Misc. - 4316 IL Route 22:
Route 22 Widening

To: David Lothspeich
Subject: RE: 4316 IL Route 22 Property Acquisition

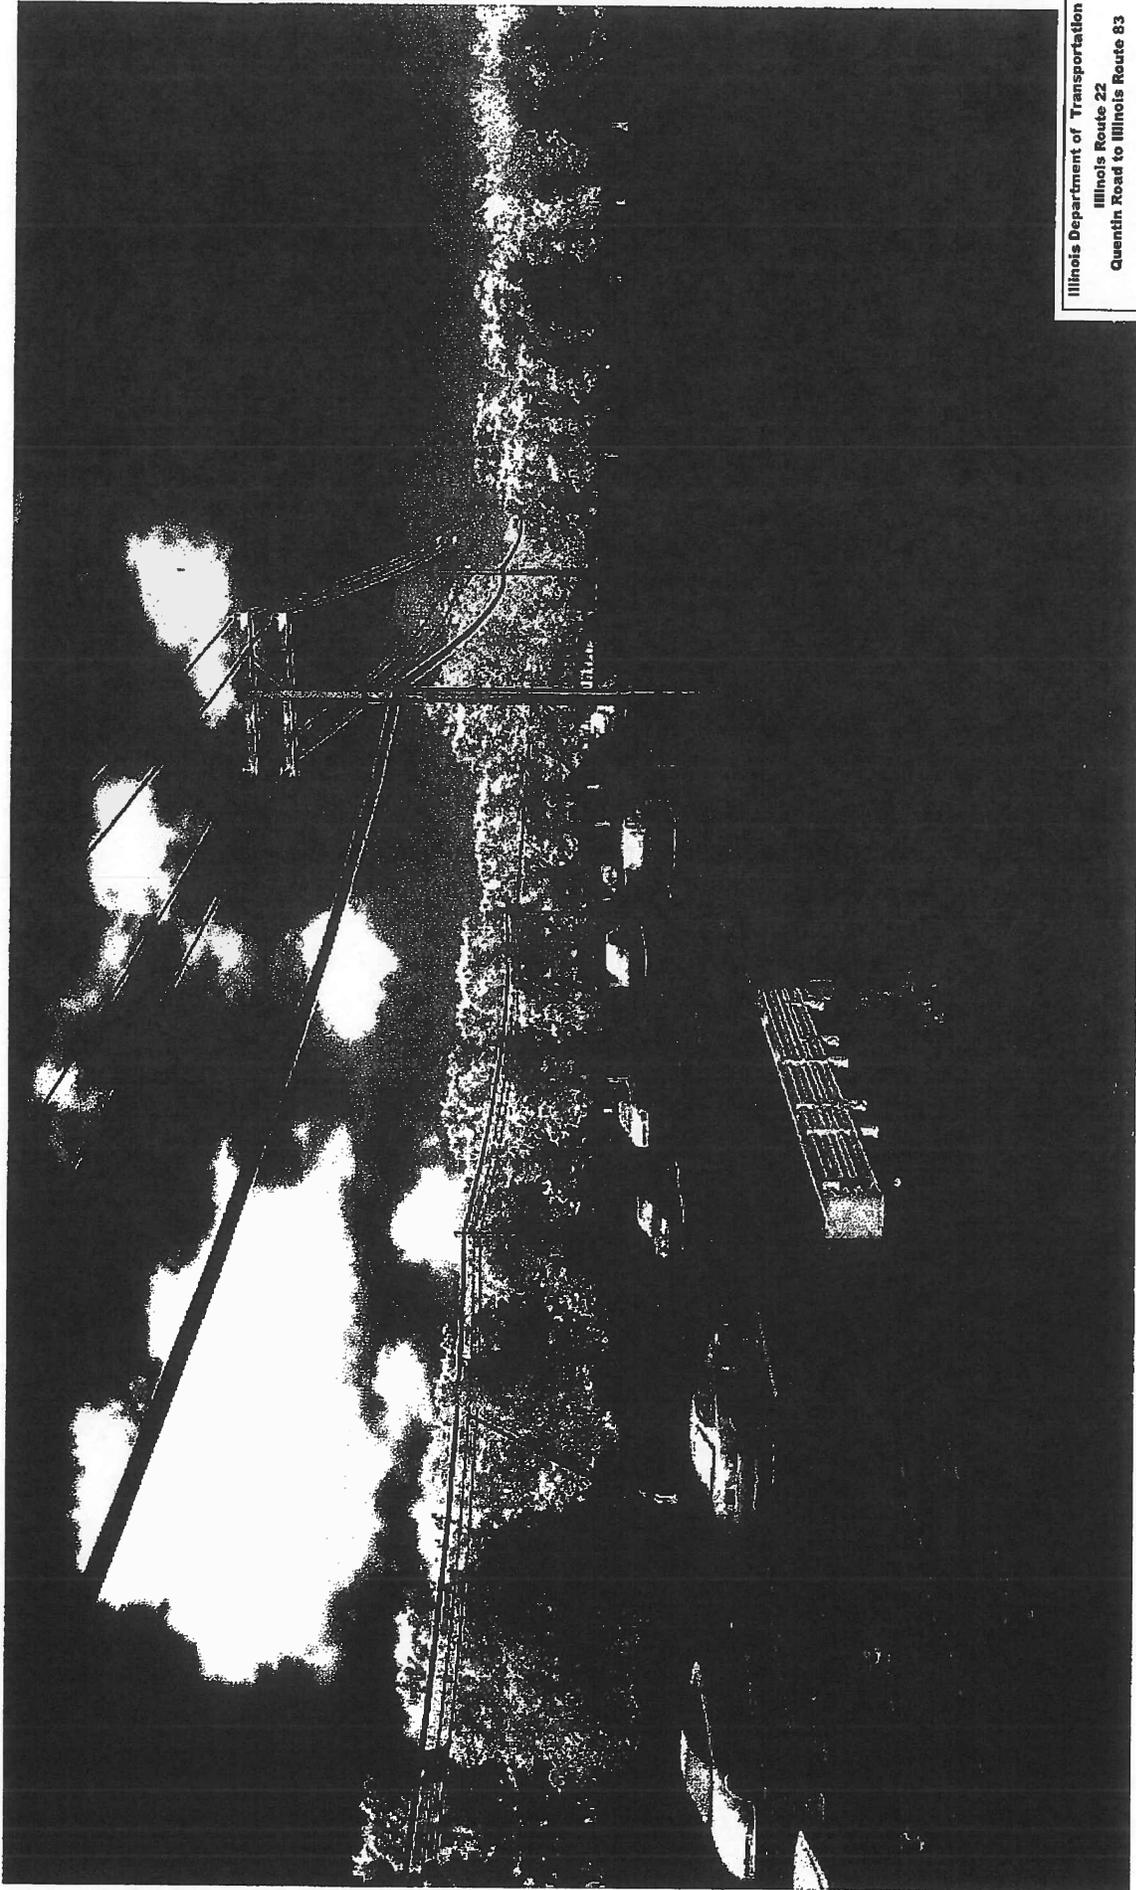
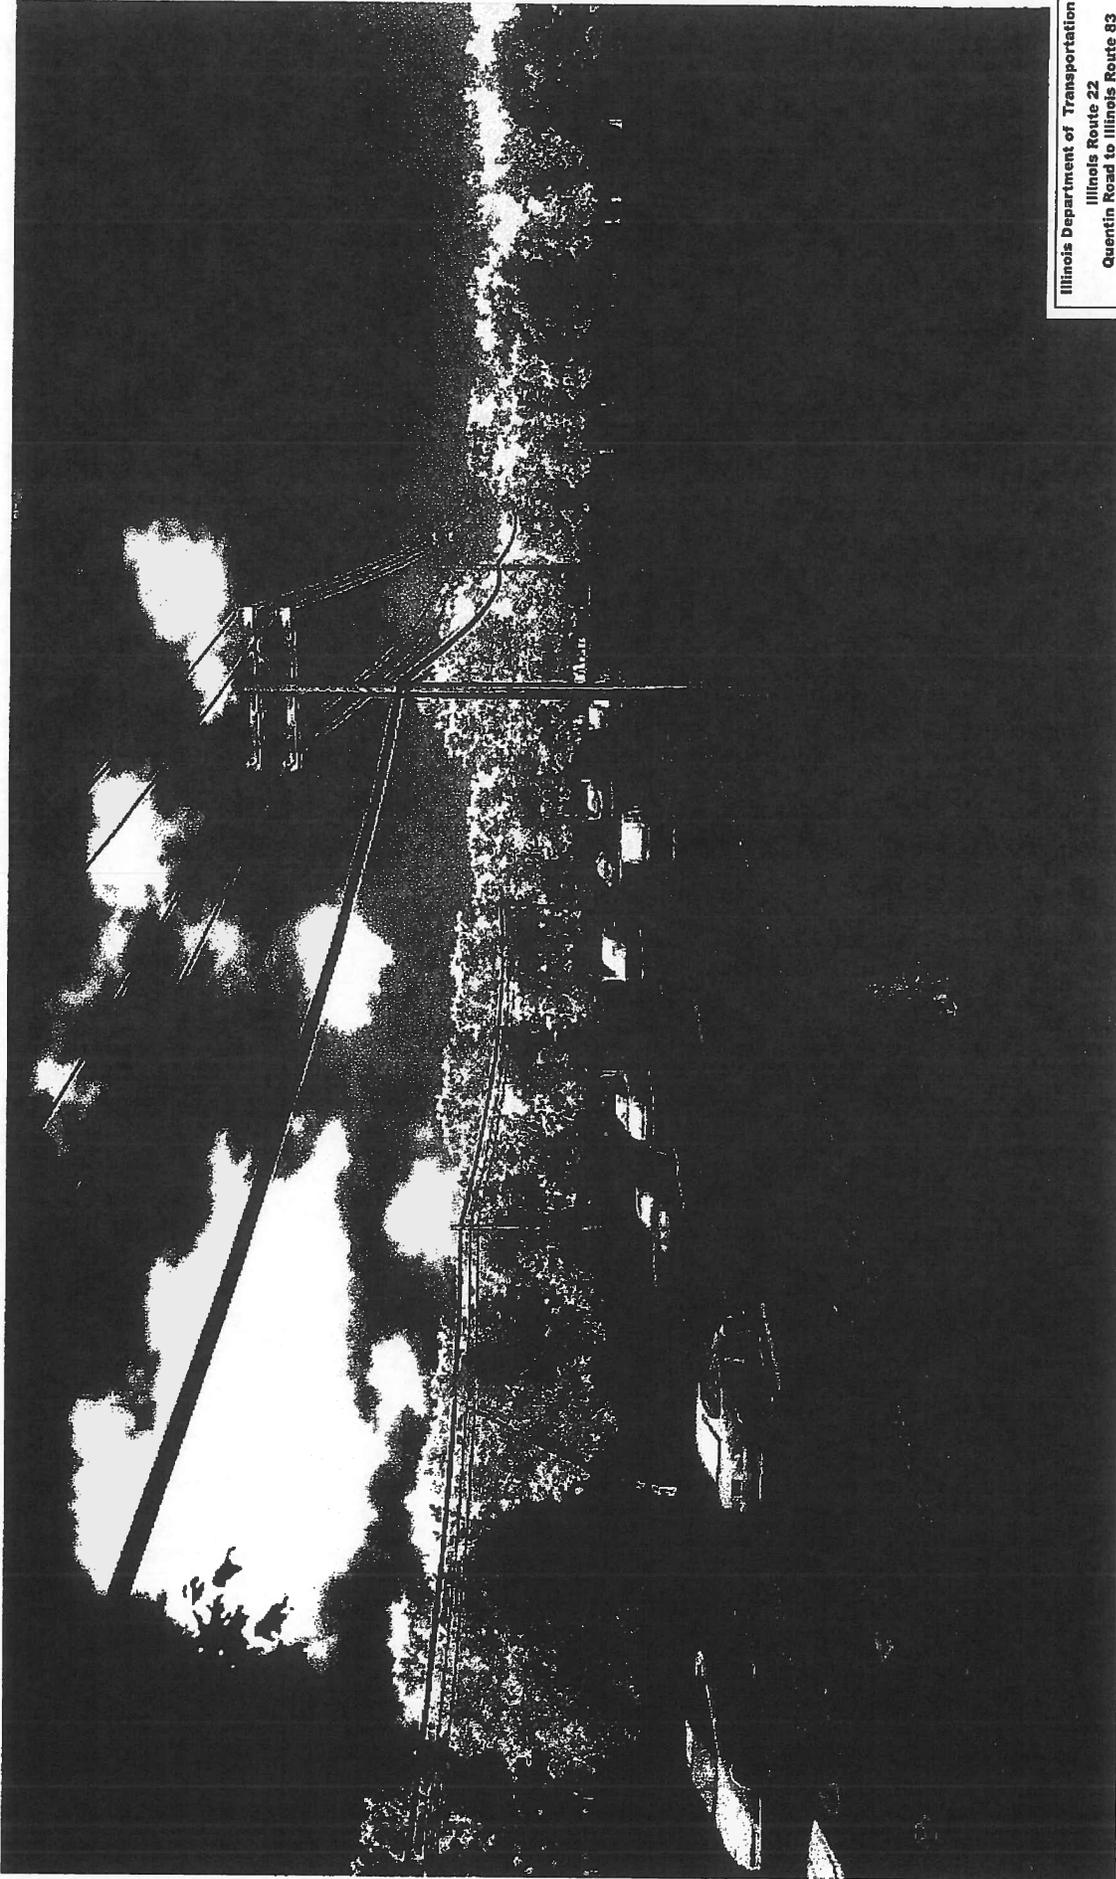
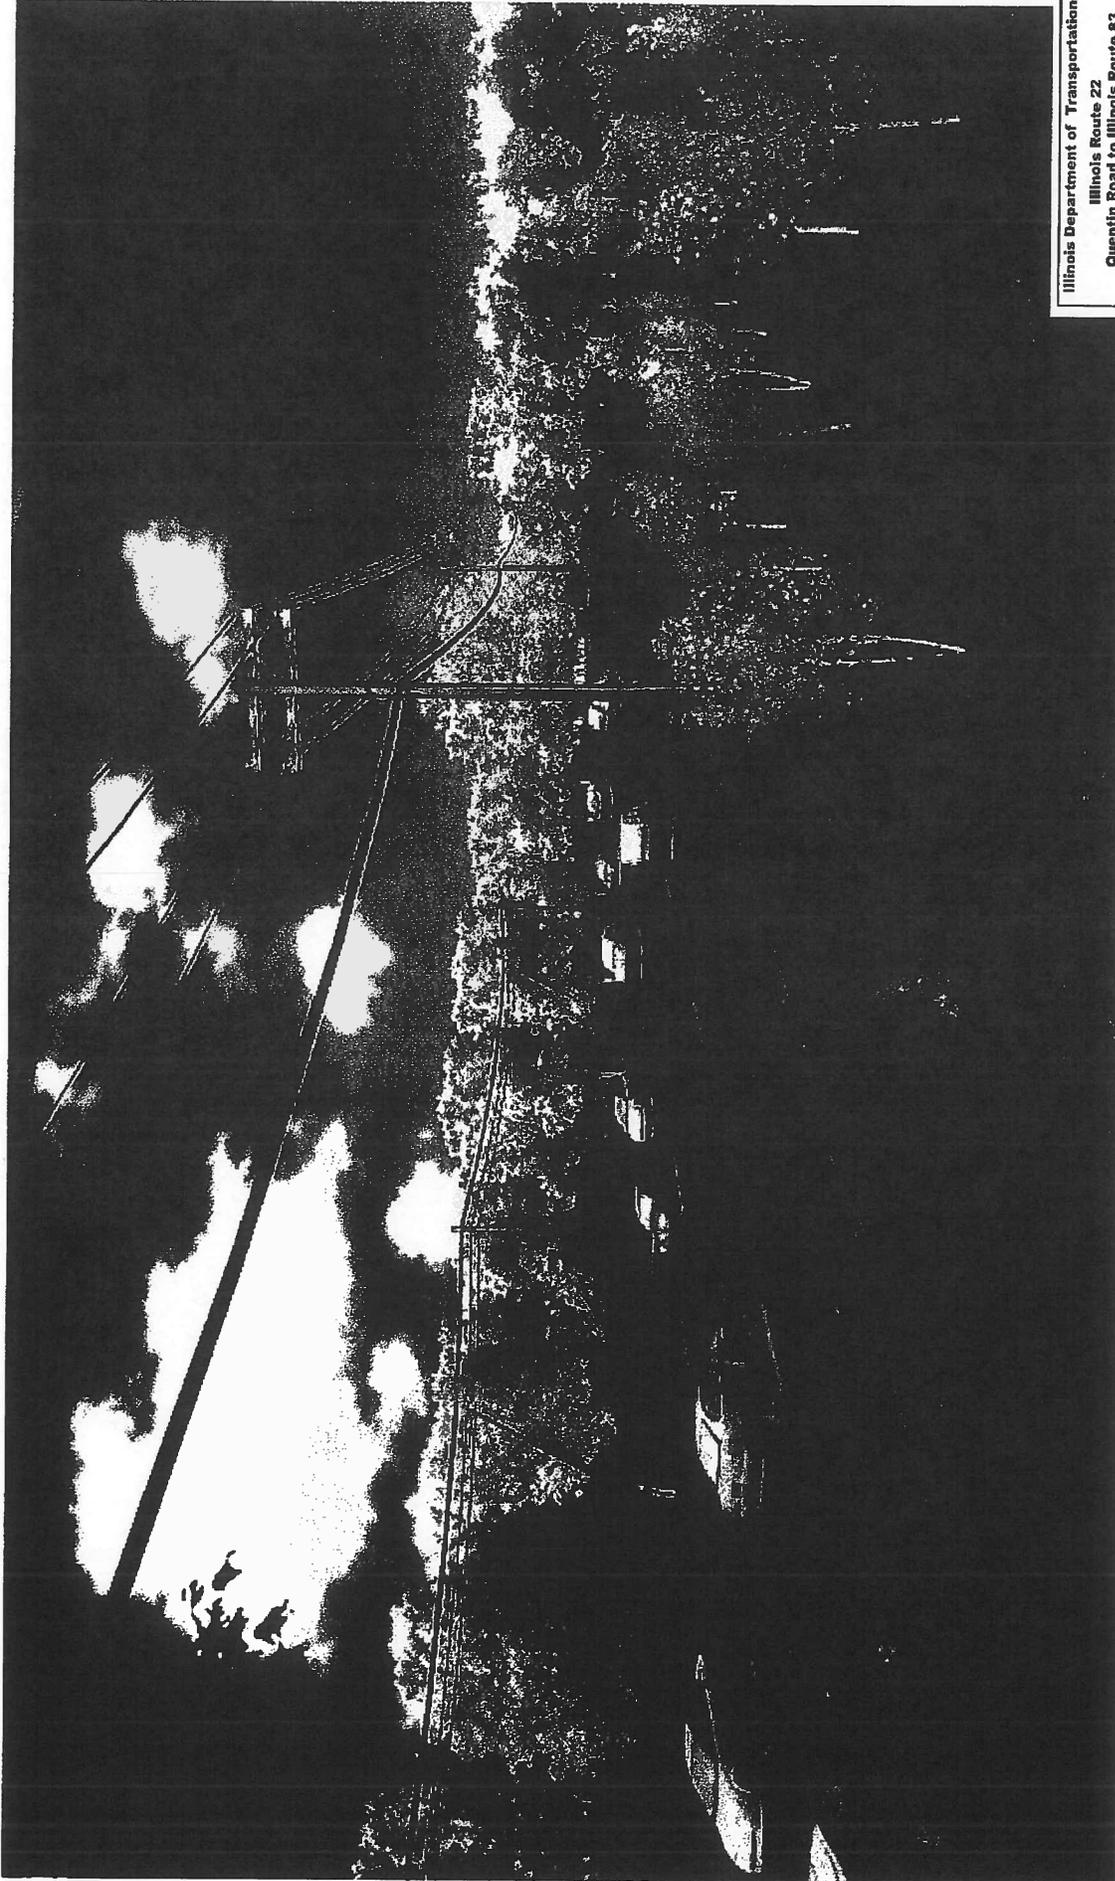
- Exhibits D-5 through D-8 show the same area as viewed from a point on Oak Creek Lane. The back of the concrete barrier wall is shown. Below is the actual retaining wall. A decorative concrete form liner could be used on this back face of the retaining wall.
